Visibility of the Seat Cushion Upholstery When the Seat Cushion Fore/Aft Adjustment Is Extended

Topic number	LI91.10-P-080033
Version	1
Function group	91.10 - Front seats
Date	4/8/26
Validity	The affected cover variants are listed below. Vehicles may be affected until the date specified: Item number Date A 294 910 62 02 9H93 - 20/06/2024 A 296 910 11 05 9E43 - 08/07/2024 A 294 910 53 02 9E38 - 11/07/2024 A 296 910 18 03 8U00 - 15/07/2024 A 296 910 17 03 1D08 - 22/07/2024 A 294 910 22 02 9K65 - 22/07/2024 A 296 910 29 03 9E38 - 05/08/2024 A 296 910 15 03 1D63 - 05/08/2024 A 294 910 23 02 9E38 - 26/08/2024 A 296 910 12 05 1D08 - 23/09/2024 A 296 910 18 03 1D44 - 11/10/2024 A 294 910 53 02 1D44 - 28/10/2024

Attachments	
File	Description
BR 294_296 - Schaumteil nacharbeiten.png	Reworking foam part

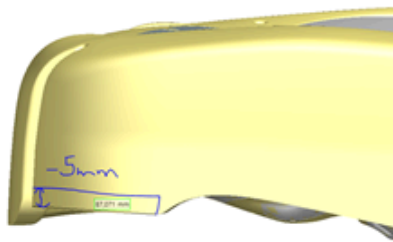
The seat cushion upholstery is visible when the seat cushion fore/aft adjustment (SKTV) is completely extended.

The stretch part of the seat cushion cover does not completely cover the padding.

An adaptation must be made to the seat bolster in the form of a cutout. To do this, please proceed as follows:

- Extend the seat cushion fore/aft adjustment (SKTV) 2 times
- Trim the foam to reduce its height by 5 mm. Remove material along the front section up to the start of the profile (approximately 85 mm), then gradually taper the cut toward the rear.
- Extend SKTV 5 more times and check whether visibility is still ensured
- If necessary, lightly rework again

If too much of the foam part is removed, there is a risk that the stretch will become too wavy when retracted.

Do not treat the stretch material in the seat cushion fore/aft adjustment area of the seat cushion cover with steam or hot air.

Seitlich vorne um 5mm in der Höhe kürzen und nach hinten auslaufen lassen
